Access Compliance Report

Public Rights-of-Way

Intersection ID: 12347	Main Street: S_CHURCH_ST	Cross Street: W_3RD_ST	Location: S
ADA ID: 38B7F908225C	Ramp Type: BlendTrans1	Initial Pass/Fail: Pass	Overall Compliance: No
Codes/Mitigation Info/Possible Solution		Field Measurements/Component Compliance	
Severity Score: 0

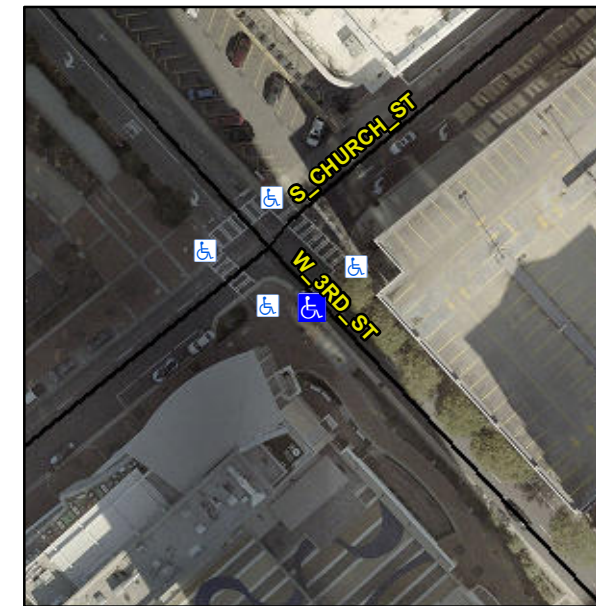
Not Found, R304.5.3

Yes	Ramp inside XWalk1?	Yes	N/A	Ramp inside XWalk2?	N/A
	Road Slope (%)	3.2		Clear Space?	Yes
	Road X Slope (%)	2.0	N/A	Clear Space to XWalk (in)	N/A
Yes	Any Obstructions?	No	Yes	Storm Grate/Utility Hazard?	No
	Obstruction Type			Storm Grate/Utility Type	
		N/A			N/A
			Yes	Surface Condition? (G/P)	Good
			No	Curb Slope (%)	12.7

Remove & Replace Curb Slope and Extend Ramp. Remove & Replace Gutter.
